STRUCTURES DESIGN BULLETIN C11-08

SUBJECT: Implementation of new Design Standards, Design Guidelines and Construction Specifications for Polymeric Bridge Fender Systems

This bulletin implements new requirements for Bridge Fender Systems.

Design Standards Indexes 21900, 21910, 21920 and 21930 have been removed and replaced in the July 2011 Interims with the drawings as shown in Attachment A as listed below.

LAYOUT GEOMETRY

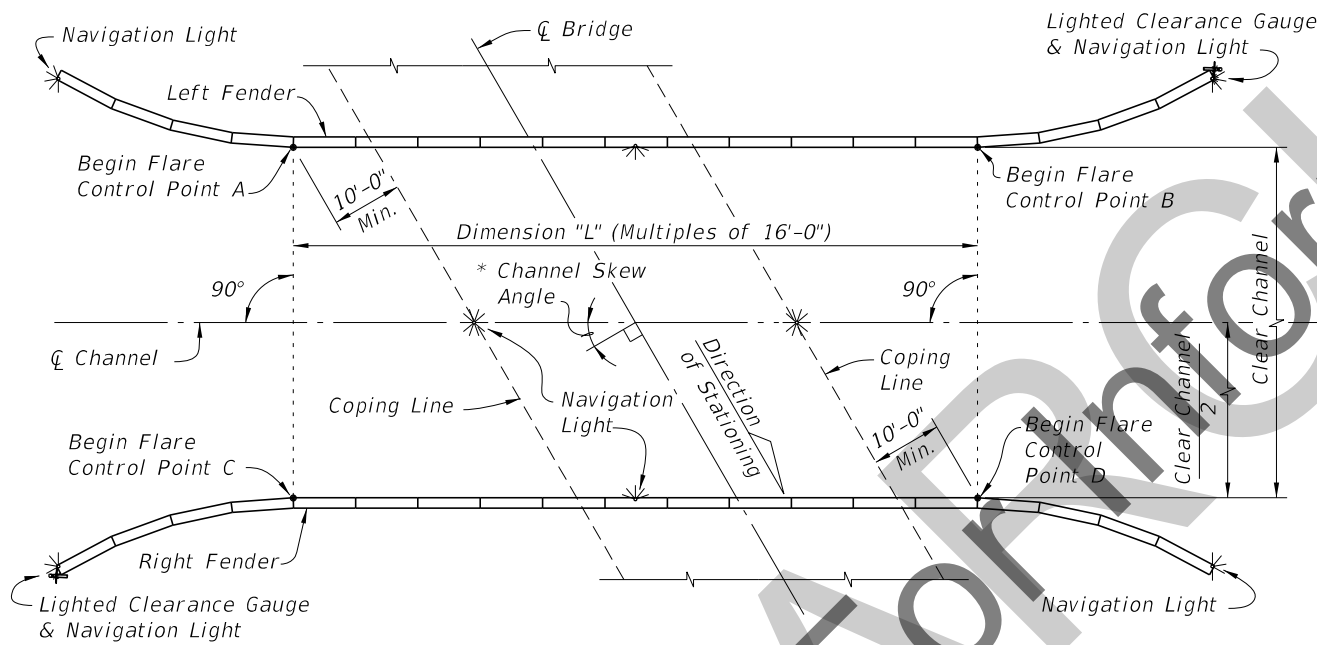
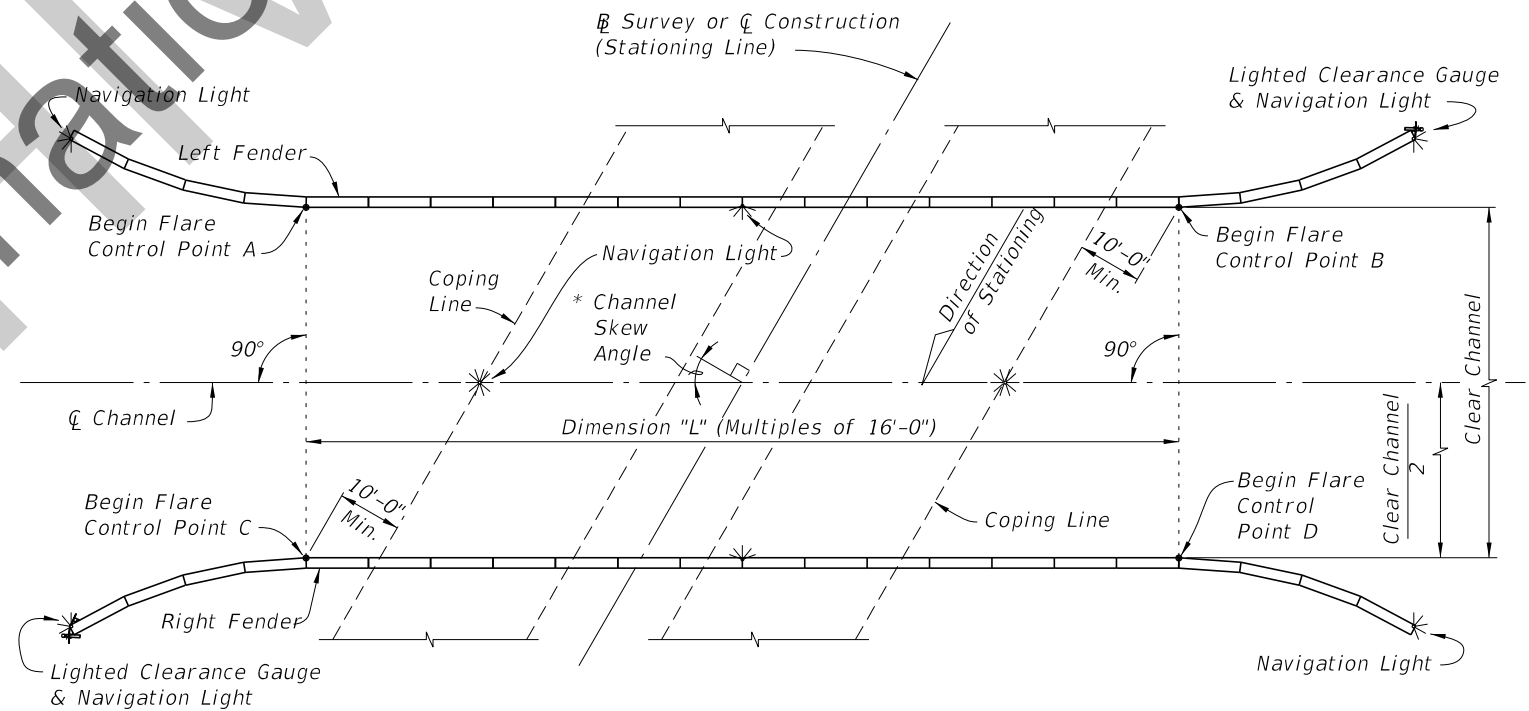
REVISIONS					
DATE	BY	DESCRIPTION	DATE	BY	DESCRIPTION
07/01/11	GJM	Added clarification that this layout geometry is for fixed bridges only; Changed title.

FENDER SYSTEM DETAILS

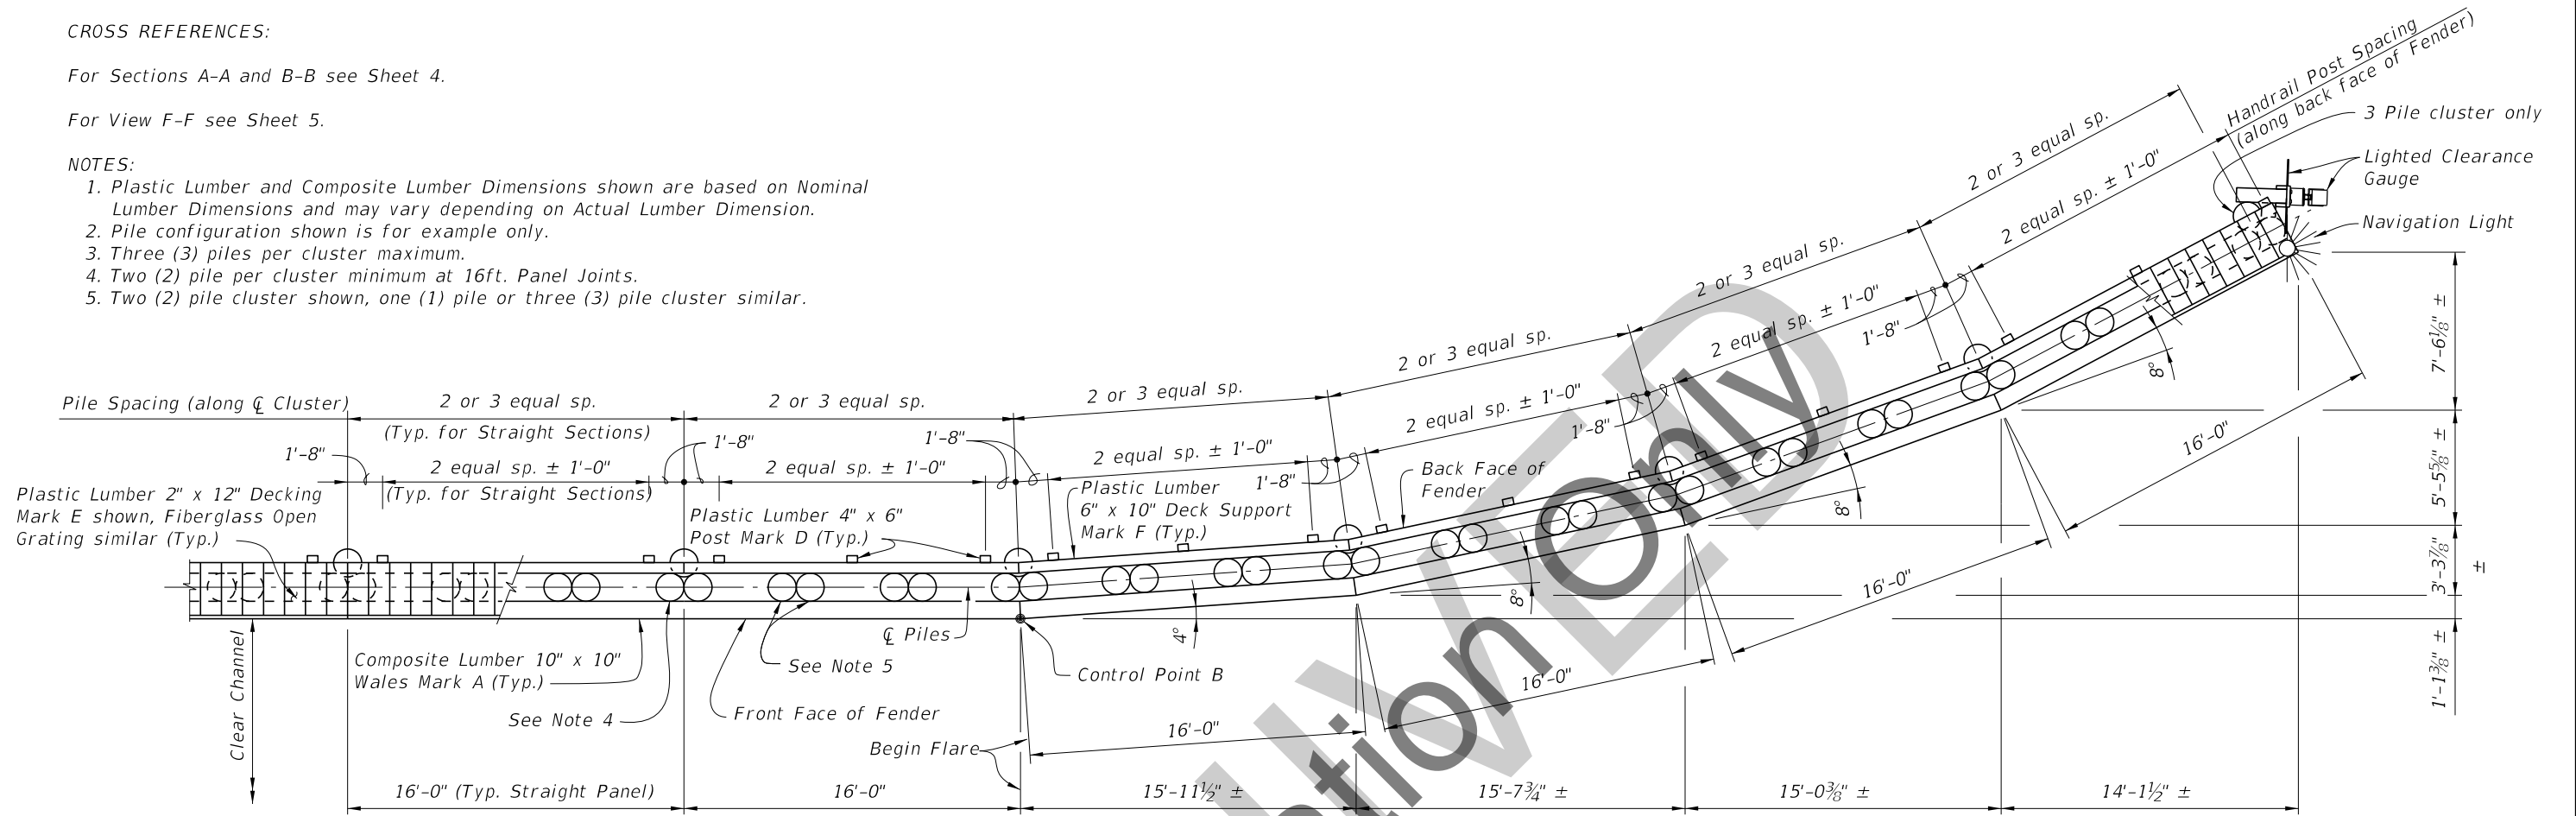
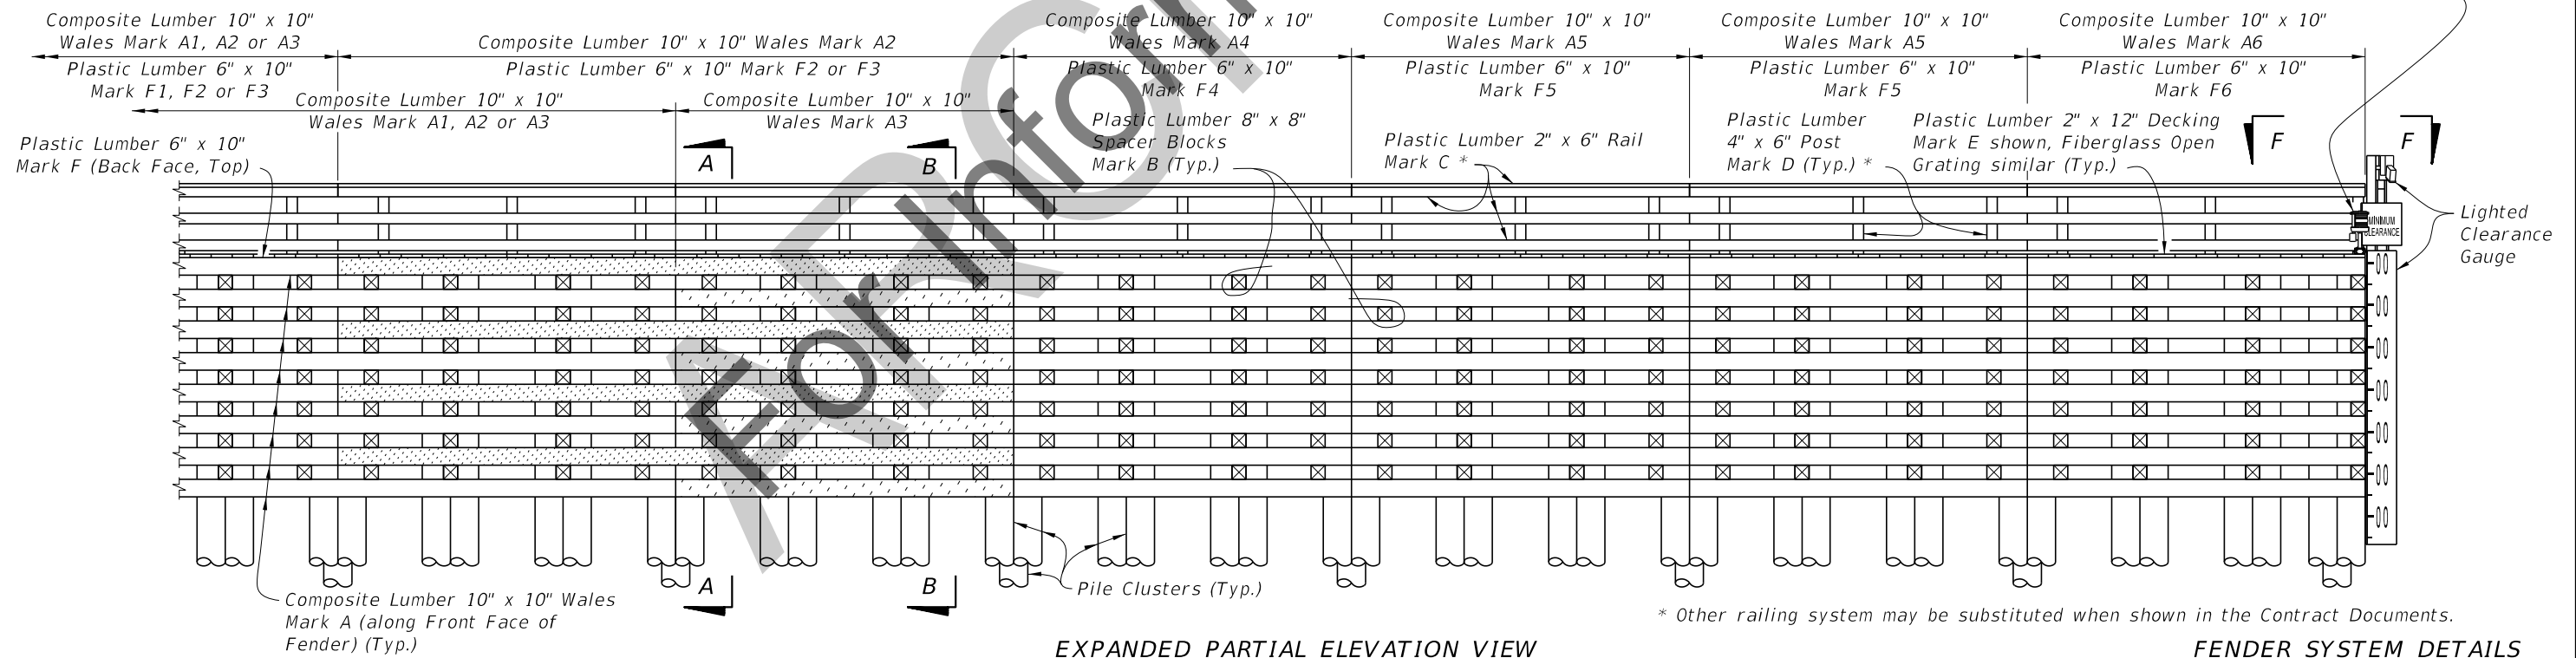
REVISIONS			
DATE	BY	DESCRIPTION	
07/01/11	GJM	New Sheet (Previously Index 21910, Sheet 1); Added piling configuration notes. Removed specific pile spacing dimensions to show allowable number of equal spaces.

FENDER SYSTEM DETAILS

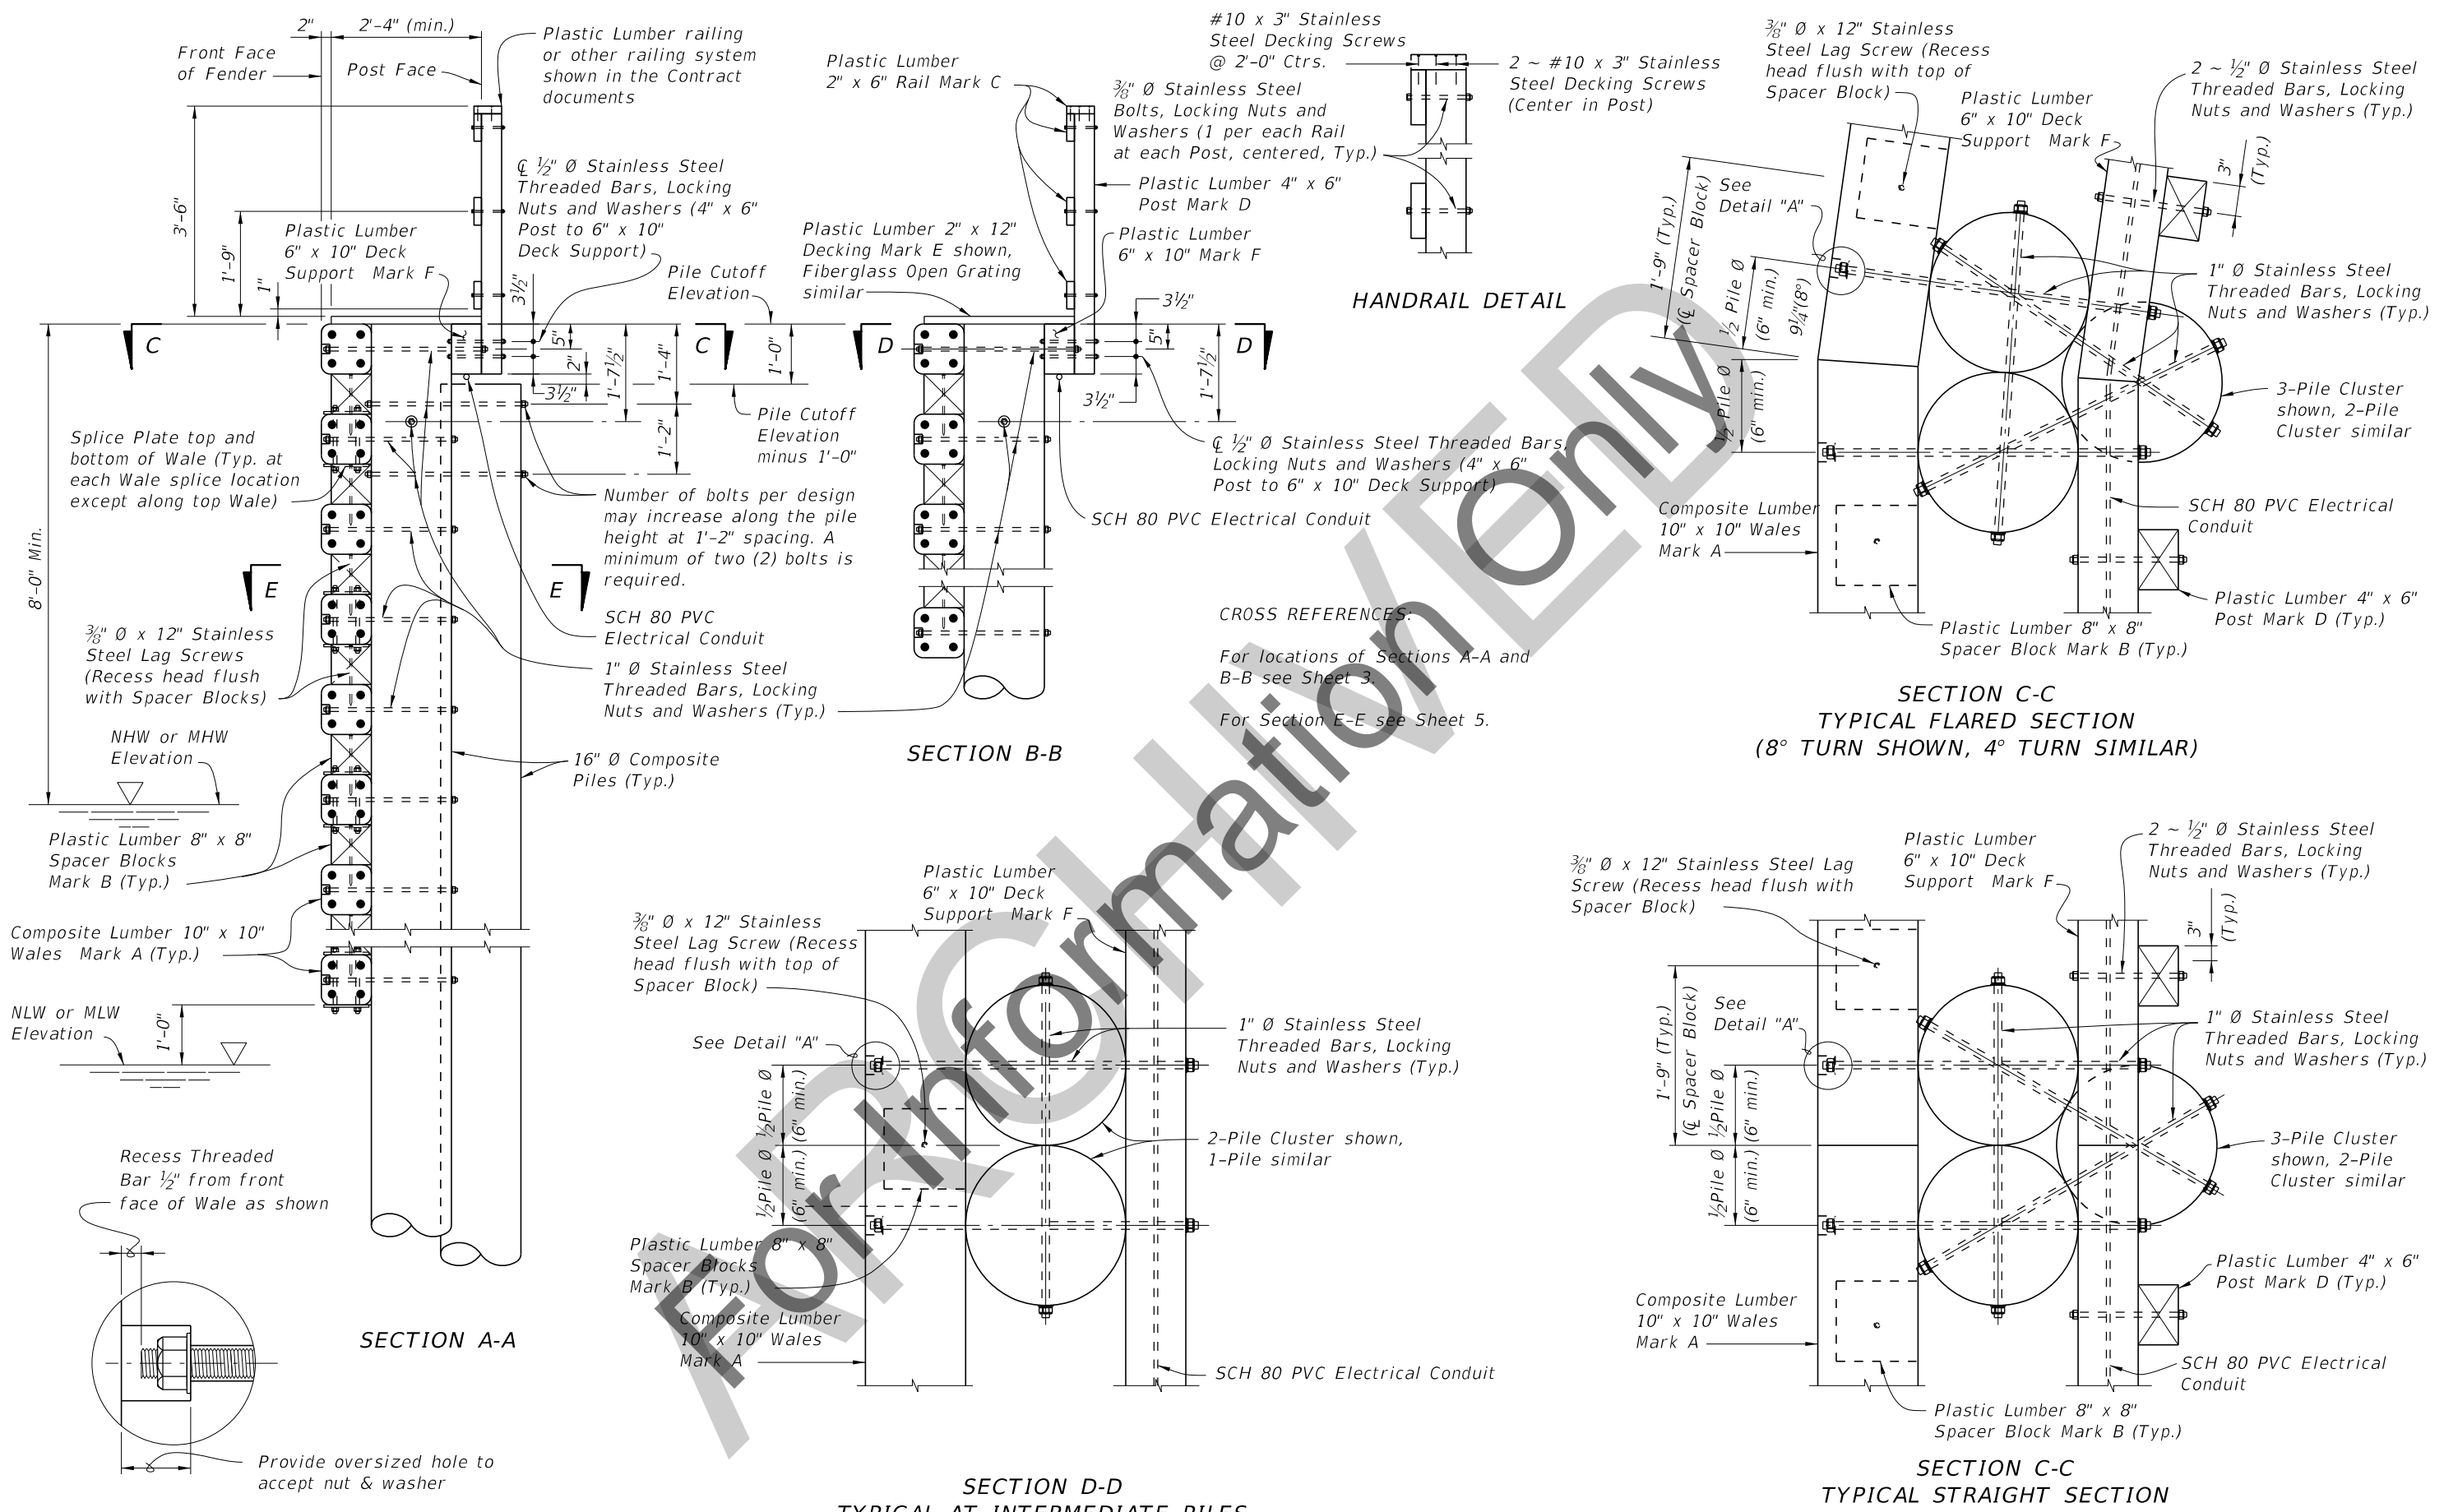
REVISIONS			
DATE	BY	DESCRIPTION	
07/01/11	GJM	New Sheet (Previously Index 21910, Sheet 2); Modified to allow for various pile types and sizes; Changed bolt configuration for connection of Mark D to Mark F.
